Item No. 3 Dugald Sewer Rehabilitation - Change to Project
File WS

RE: DUGALD SEWER REHABILITATION – CHANGE TO PROJECT

REPORT DATE: March 23, 2006

Dugald Sewer Replacement: Recommended Design

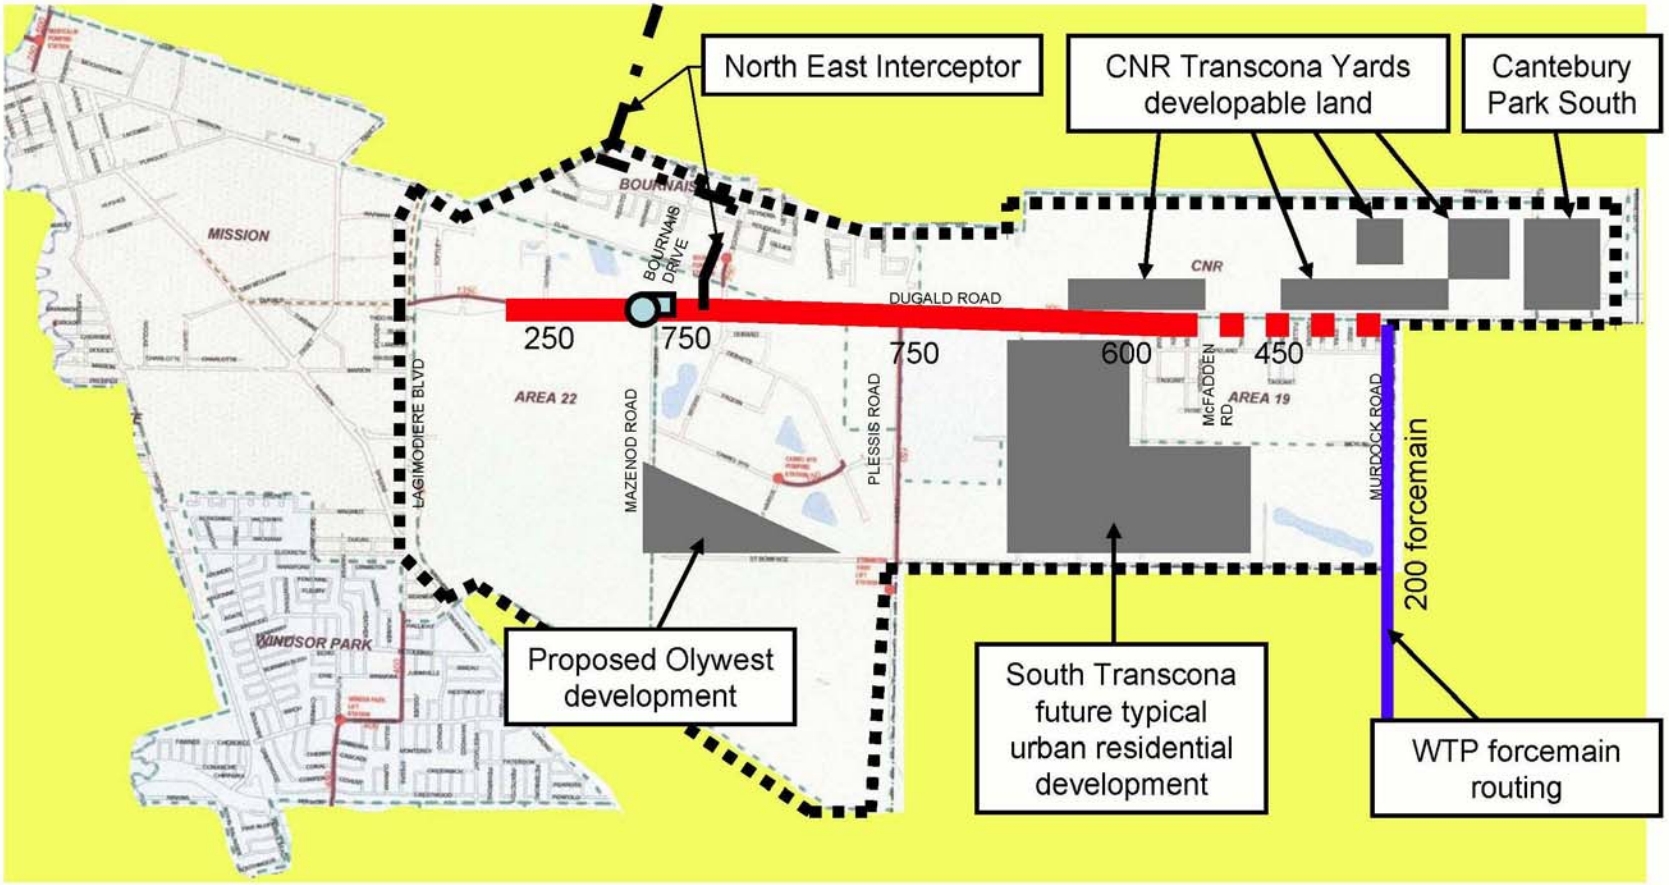
- Extend the Dugald Sewer approximately 1,250 metres further east to Murdock Road to facilitate the connection of the forcemain from the water treatment plant and the development of the Cantebury Park South Area of Transcona (see attached map).
- Increase the sewer sizes from Murdock Road to Bournais Drive to accommodate the increased peak flows expected from residential densities assumed for South Transcona.
- Increase pipe size from Mazenod Road to Bournais Drive to accommodate peak flow expected from wet industrial development in the St. Boniface Industrial Park.
